CHANGE ORDER NO. 16

PROJECT: <u><i>Horizon City Municipal Facilities Phase I</i></u> OWNER: TOWN OF HORIZON CITY 14999 Darrington Rd. Horizon City, Texas 79928 CONTRACTOR: <u><i>Dantex General Contractors</i></u> <u><i>4727 Osborne</i></u> El Paso, TX 79922 CONTRACT FOR: <i>New Municipal Facilities for the City of Horizon</i>	DATE OF ISSUANCE: February 4, 2026 EFFECTIVE DATE: February 4, 2026 OWNER'S BID NO. CSP 23-038 Project No. 2.513D ARCHITECT: Eugenio Mesta, AIA Exigo Architects 211 N. Florence Ste. A El Paso, Tx 79912 ARCHITECT'S PROJECT NO: 20201600
--	---

Item No. 1: *Additional Power and PDU for Emergency Services* - (\$ 34,106.94; 25 days impact to contract time)

To: DANTEX Construction
From: Jesus Ortega, EXIGO Architects
Project: HCMF
Date: 1 /15 /2025
Re: **ASI 009 – New Power request for IT Rm**

E3.0R3

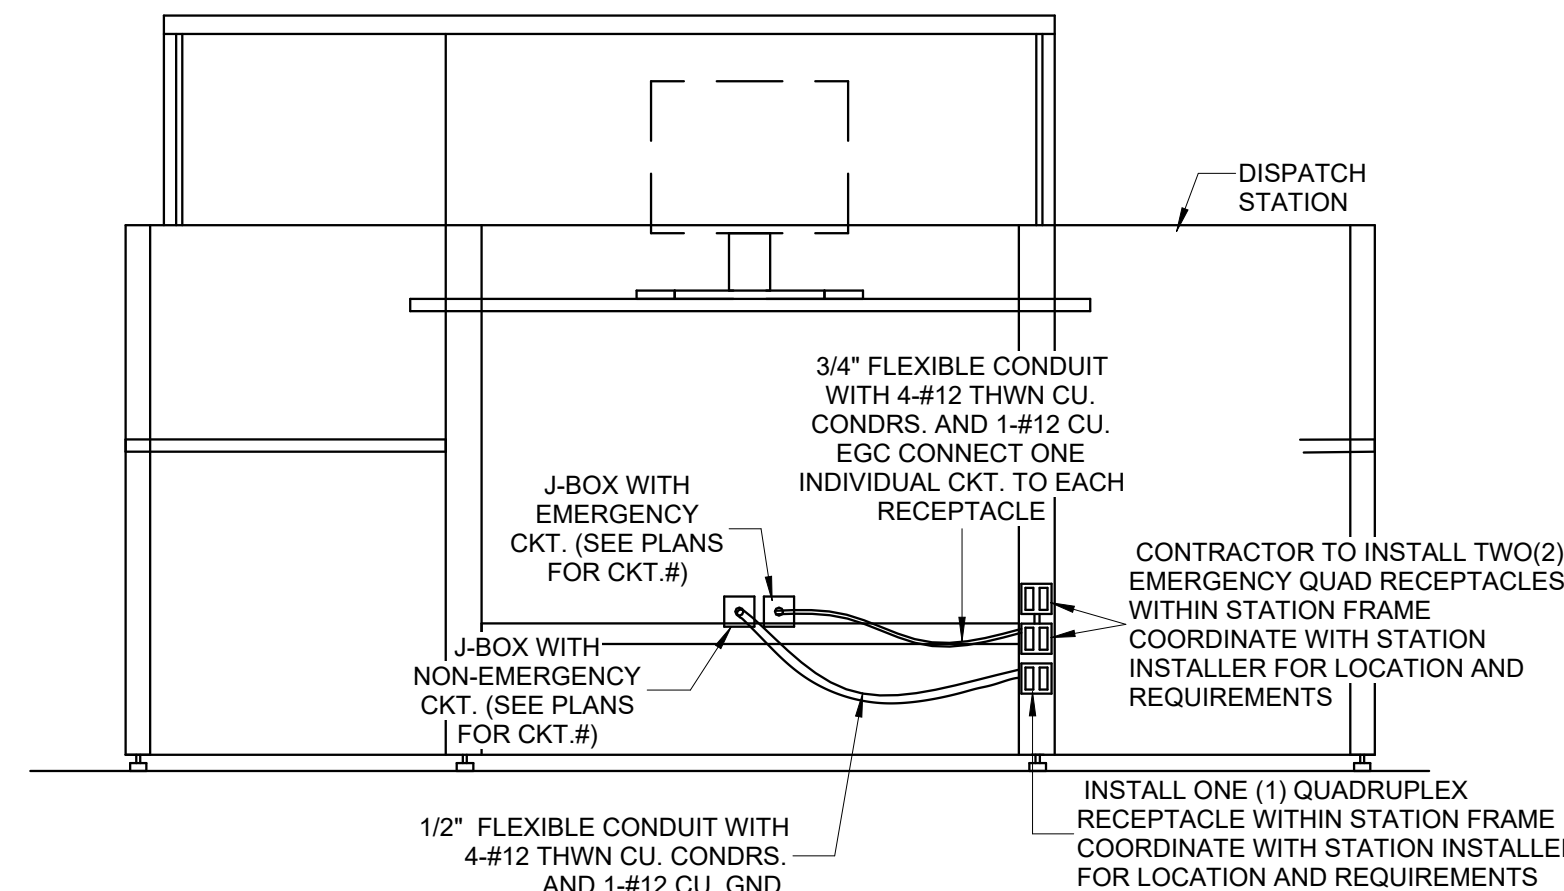
The Town of Horizon is requesting additional power for the IT room.

- a) ASI 007 – E3.0R3 – Delta#5: Power Plan “A”_
- b) ASI 007 – E6.1R2 – Delta#5: Panel Schedules

- PROVIDE AND INSTALL (4) 30 AMP, 240V, TWIST-LOCK RECEPTACLE NEMA L6-30 WITH CIRCUITS, AS SHOWN FOR DATA RACKS. INSTALL (2) RECEPTACLES IN CEILING ABOVE EACH DATA RACK. COORDINATE WITH OWNER FOR EXACT LOCATION.
